STATE OF WASHINGTON
DEPARTMENT OF ECOLOGY

Re: Water Quality Certification for U.S. Army Corps of Engineers Public Notice 1996-4-02325 (Amended-1); Construction of a Third Runway and related projects at the Seattle-Tacoma International Airport (STIA) in the Miller, Walker, and Des Moines Creek watersheds and in wetlands at the Seattle-Tacoma International Airport, located within the vicinity of the city of SeaTac, King County, Washington; and in wetlands at the mitigation site in Auburn, King County, Washington.

PROJECT: Port of Seattle Third Runway & Master Plan Update Projects

Borrow Area 3 Wetland and Swale Buffer

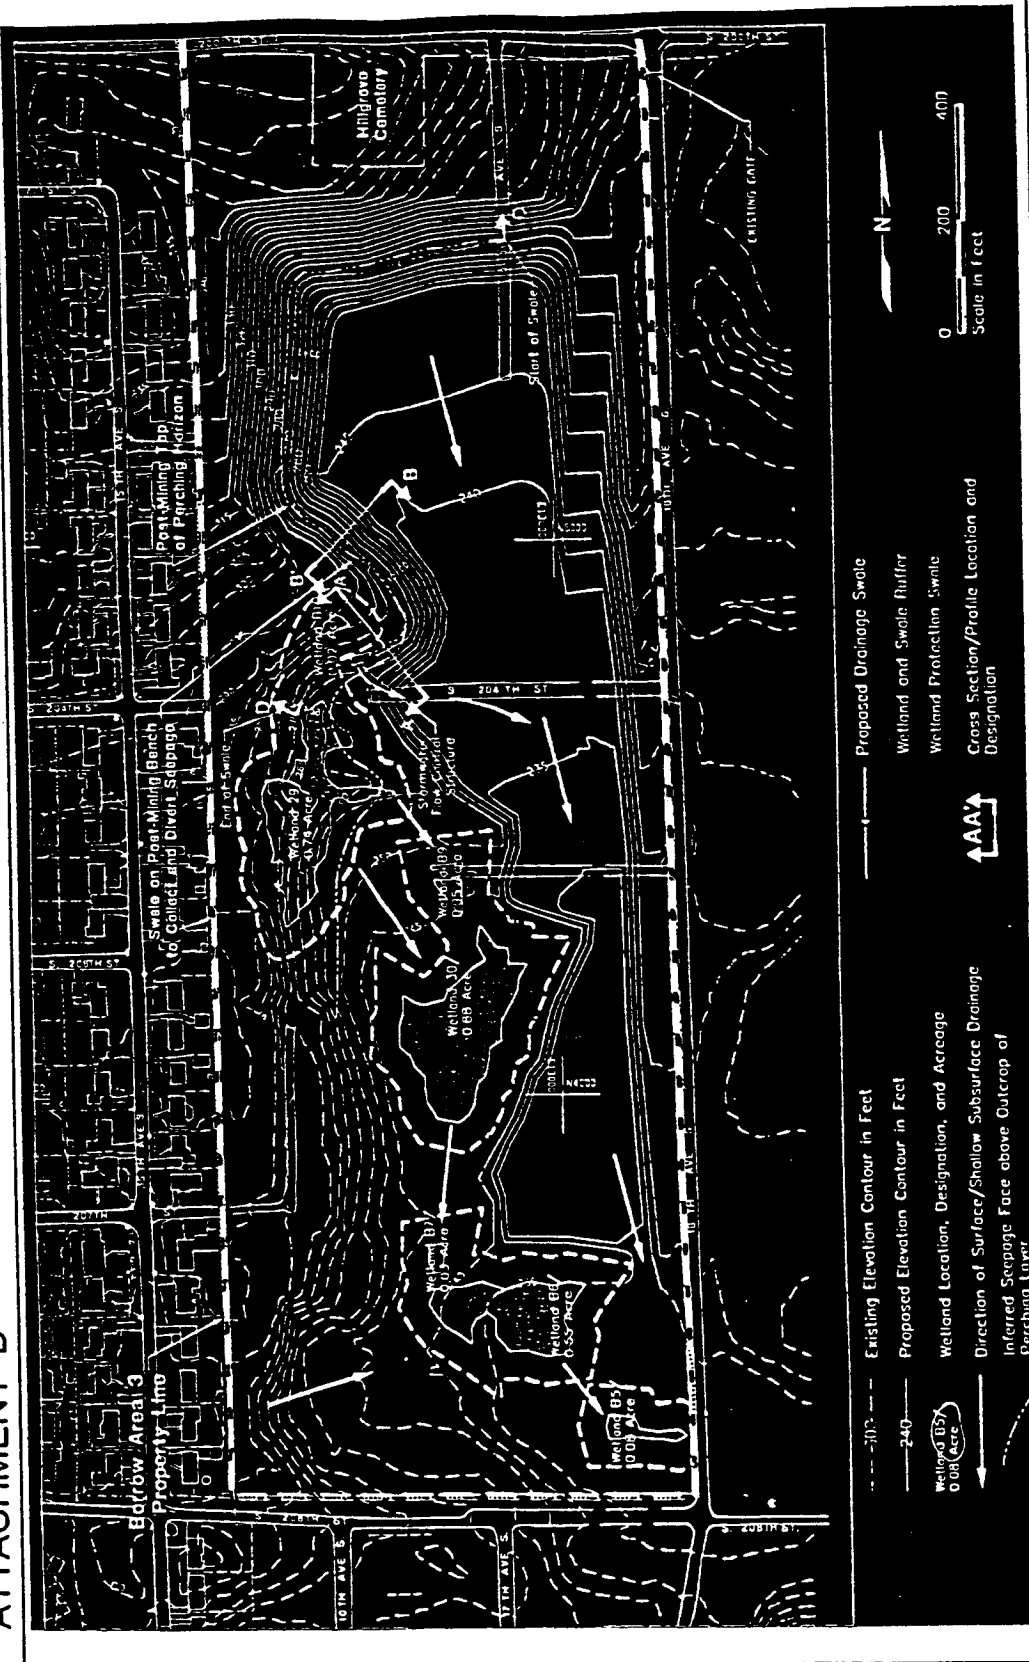
- a) The site plan from Hart Crowser titled Post Reclamation Topographic detail Borrow Area 3 Wetland Protection Swale HNTB revision (June 15, 2001 Draft) shows a flow dispersal trench overlapping with a small portion of Wetland 29. The flow dispersal trench shall not be constructed so that it is in the wetland.
